**INVITATION TO BID NO:** RFB-232-20

**FOR:** FFA Cabins, Shop and Miscellaneous Construction  
FFA Leadership Training Center  
Hardinsburg, Kentucky

# Addendum 02

Date: 16 June 2020

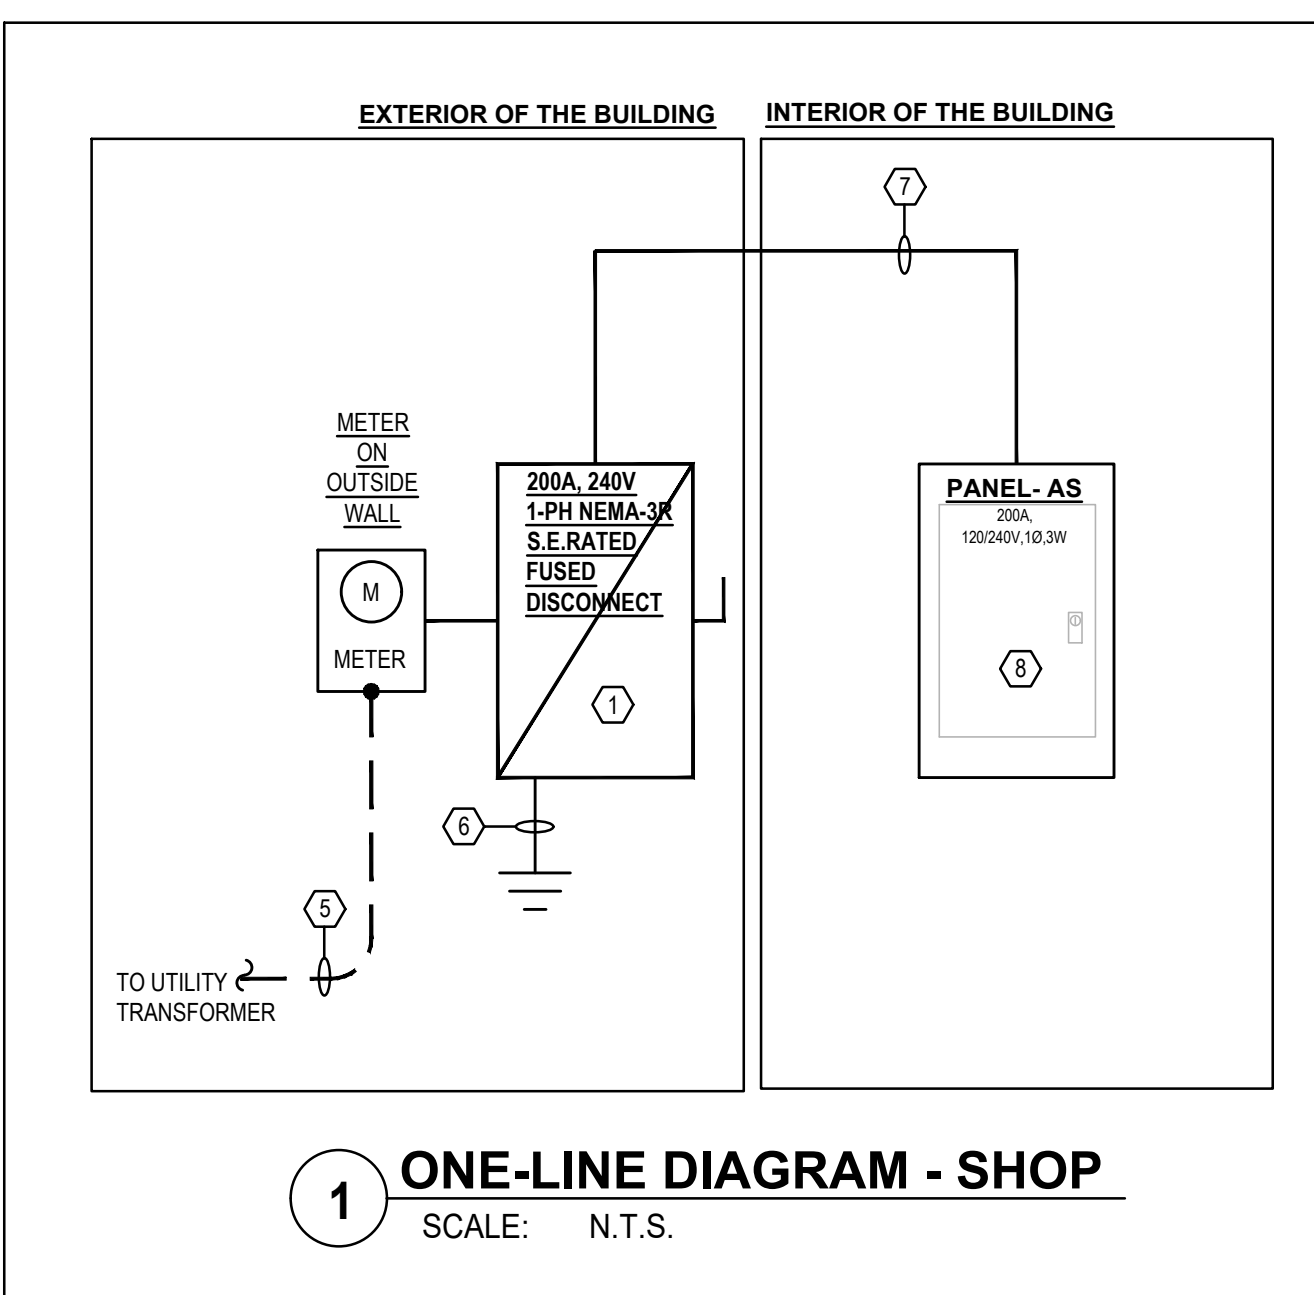
Please provide information on the three buildings underground electrical service entrances. Specifically, where we are to extend them to. Reference plan page E101 Electrical Key Note #6 and plan page E102 Electrical Key Note #4.

- a. Cabins: Reference drawings A100, E103 – "One Line Diagram", and attached Electrical Service sketch for location of utility transformer and panel for Cabins A and B.

- b. Maintenance Shop: Reference drawing A100 and attached Electrical Service sketch for location of utility transformer for the Maintenance Shop. For new electrical service at Maintenance Shop, coordinate with local utility (KU) for new service connection to existing transmission lines on property. Coordinate transformer/service panel location with Owner and GC, and provide site repair, re-seeding, etc. as required to restore site after work has been completed.

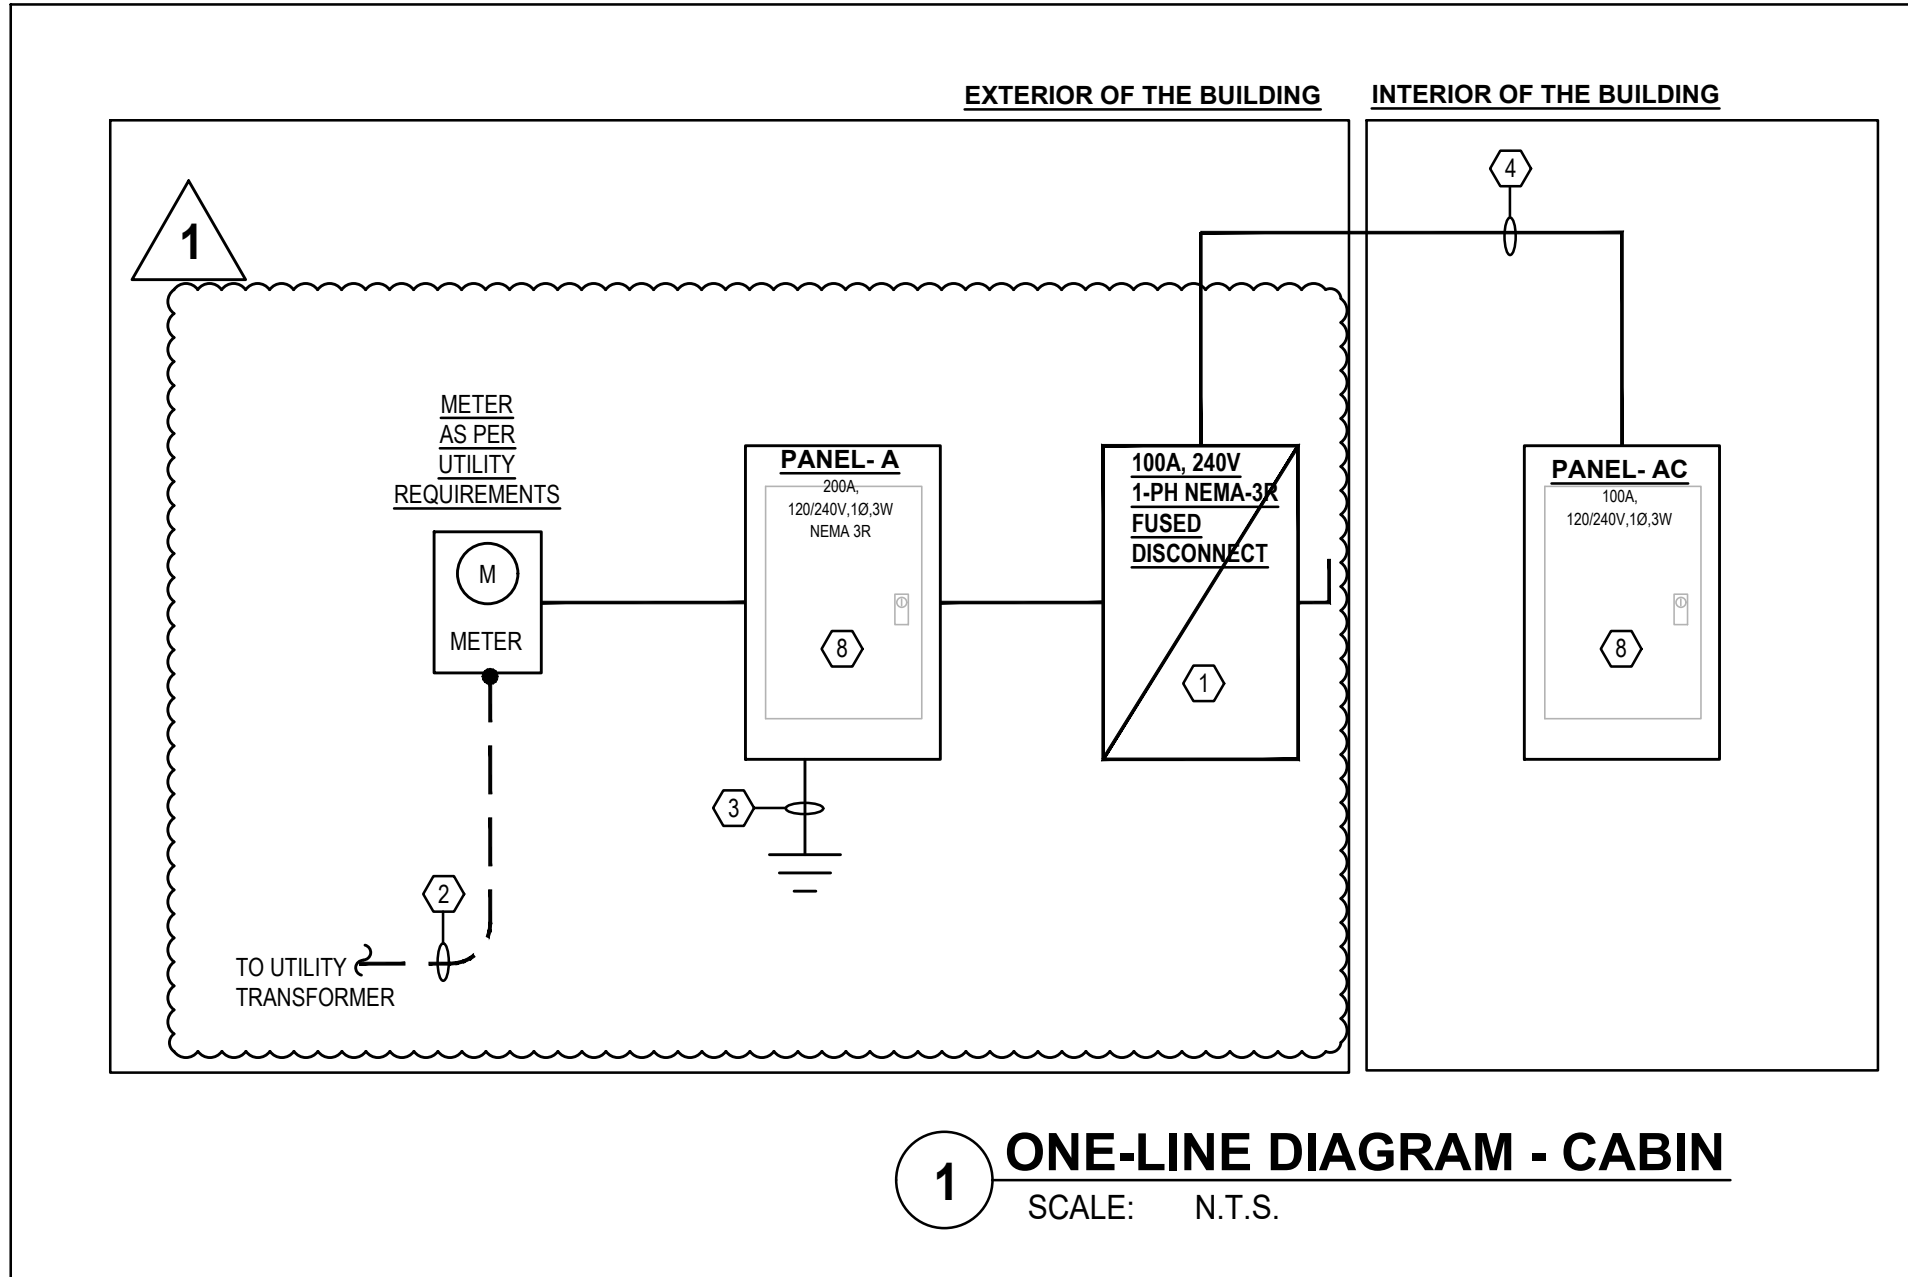
On the plan page E103 One Line Diagram for the Shop, the main disconnect switch is 1 phase and the panel is 3 phase. Please clarify which phase is to be used.

Reference drawing E103, panel "AS" (Shop) – the panel shall be single phase, three-wire in lieu of 3 phase, four-wire
